ANSWERS OF CONSUMERS POWER COMPANY
TO INTERROGATORIES (SET II) PROPOUNDED BY
CHRISTA-MARIA, ET AL.

DOCKET 50-155 - LICENSE DPR-6 - BIG ROCK
POINT PLANT - ADDITIONAL INFORMATION RELATIVE
TO FUEL HANDLING ACCIDENT IN CONTAINMENT

BIG ROCK POINT PLANT CONTAINMENT PURGE SYSTEM

DOCKET 50-155 - LICENSE DPR-6 -
BIG ROCK POINT PLANT - CONTAINMENT
PURGE SYSTEM, SINGLE FAILURES

Sketch No 1 Cal No -
 Project No F.H.A.I.C.
 Originator M.D. J. B.
 Reviewed by -
 Approved by -
 Date 9/26/73 Page 1 of 1

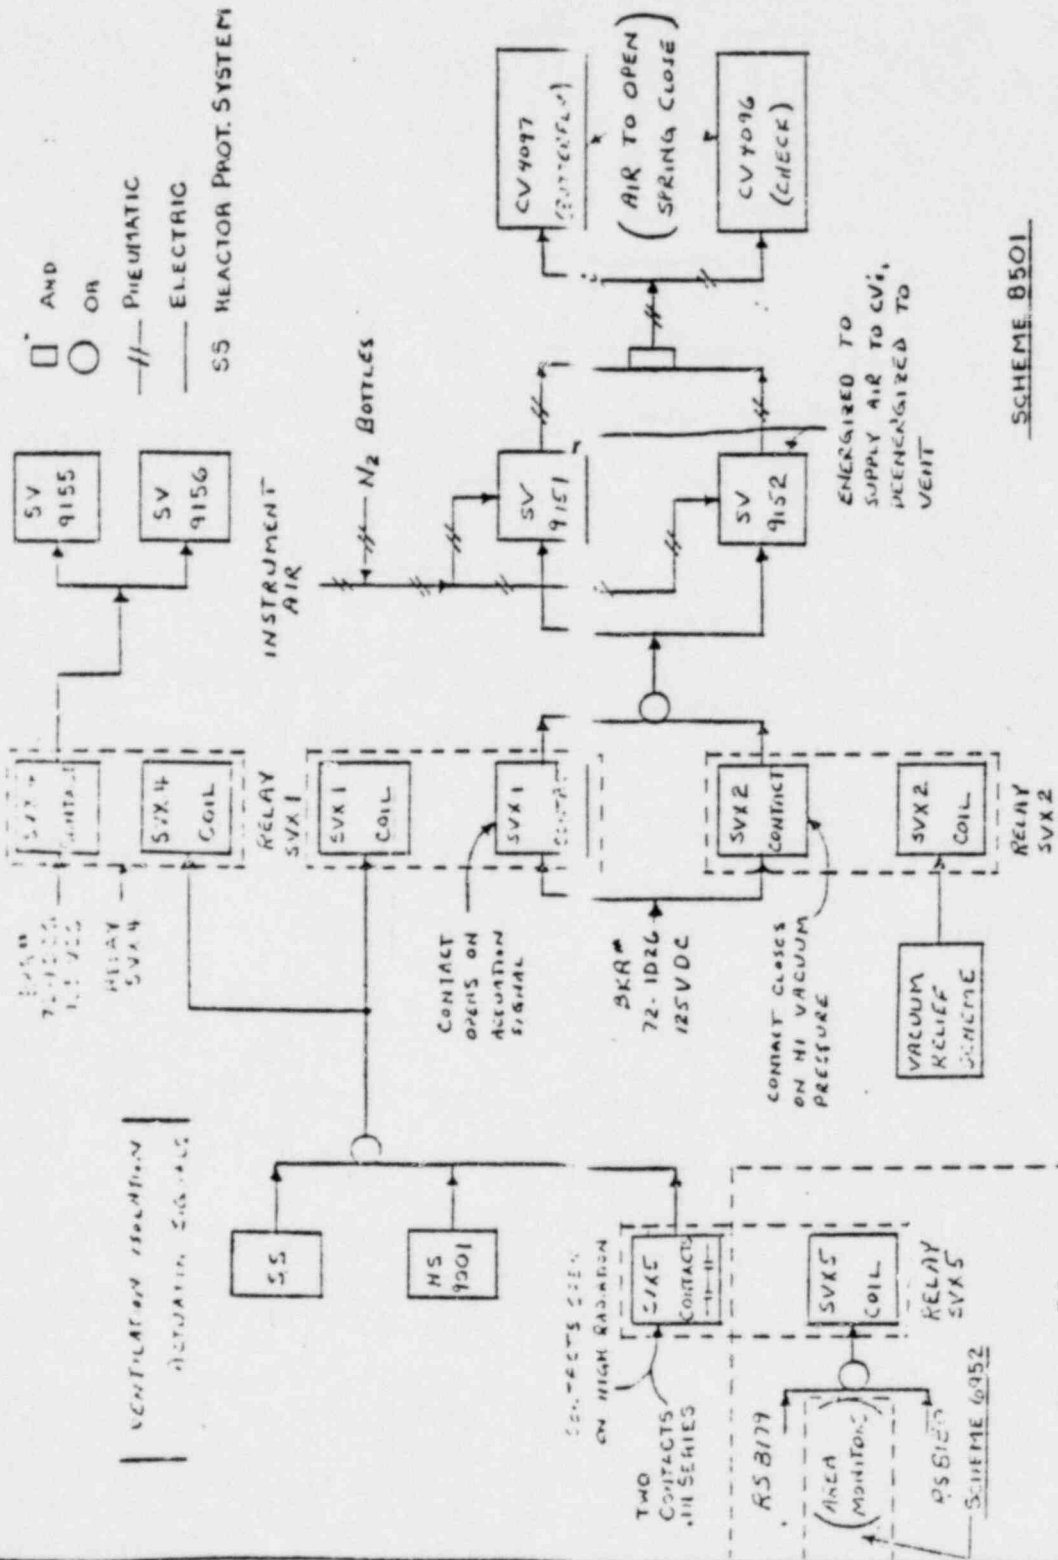
Analysis II (Attachment VI) identifies the fact that the existing ventilation isolation system control circuitry does not meet the single failure criteria as established by IEEE Standard 379-1977. The postulated failures that do not meet single failure criteria are "stuck" contacts, mechanical failure of the solenoid valves and "hot shorts."

The Logic Diagram for the air supply valves, Scheme 8501, is shown on Sketch No 1, Attachment III. The two series air supply valves (see 0740G40125, Attachment II) to the containment are labeled CV-4096 and CV-4097. One valve is a butterfly, the other is a check. These are pneumatically operated valves that require air to open but are spring to close. This feature makes the isolation valves "fail-safe" on loss of instrument air.

LOGIC DIAGRAM
FOR
SINGLE FAILURE ANALYSIS
OF CONTAINMENT ISOLATION SYS
DURING A F.H.A.I.C.

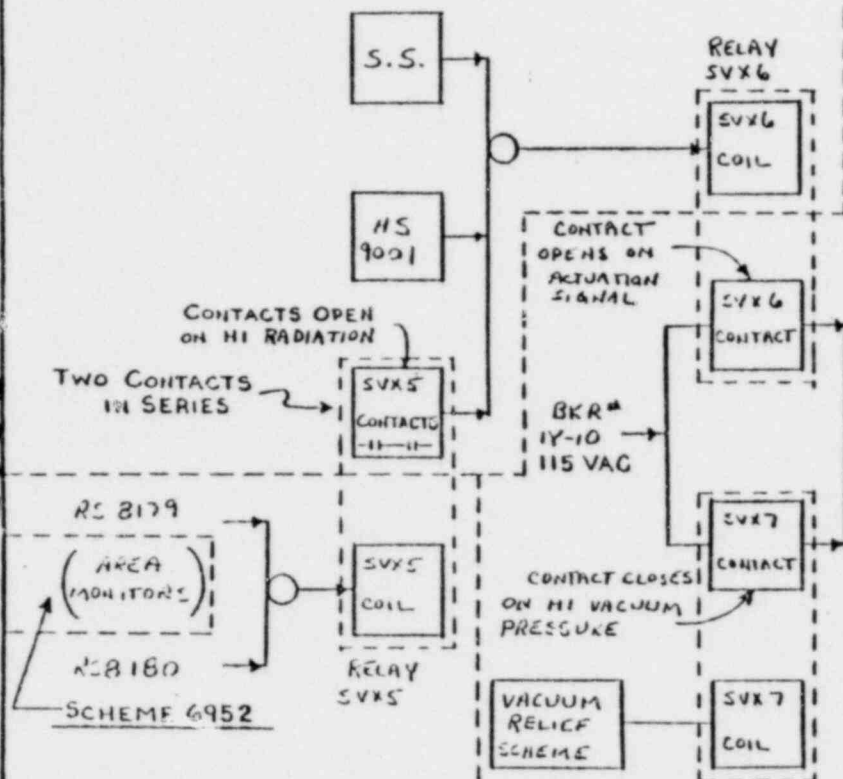
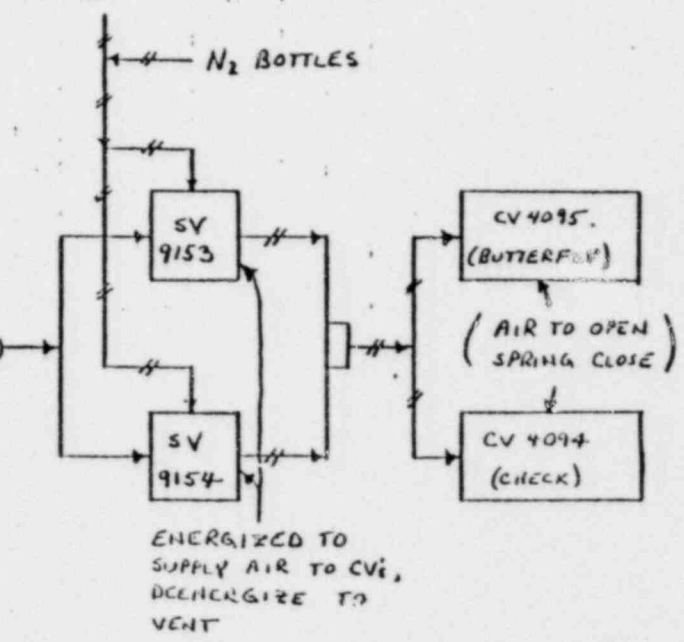
I. Single Failure Analysis for Air Supply Valves, Scheme 8501

The power supply for the isolation scheme is a 125 V d-c breaker. A postulated loss of power would de-energize the SVs and allows the CVs to "fail-safe." Inasmuch as power is not required to provide containment isolation, the single failure criteria for this component is met.
